Amendments to the Drawings:

ARGUMENTS/REMARKS

Fig. 2B

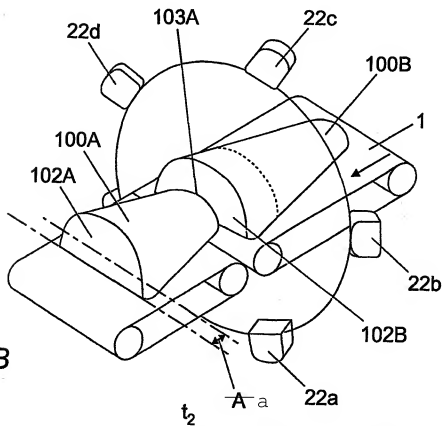
The attached sheets 1-5 of replacement drawings reflected by Figs. 1, 2A, 2B, and 3-7 include changes to Figure 2B, where the reference “A” was changed to an “a” so that it now conforms to the description. Figure 3 has been amended to remove the references “103B” and “122”, as they are not used in the description. In figure 5 the reference “122” has been removed. A new drawing is provided as figure 7 that is a copy of figure 1, but with transition markers shown as described in the specification utilizing unused reference “5” for the transition markers.

Lower Case Letter
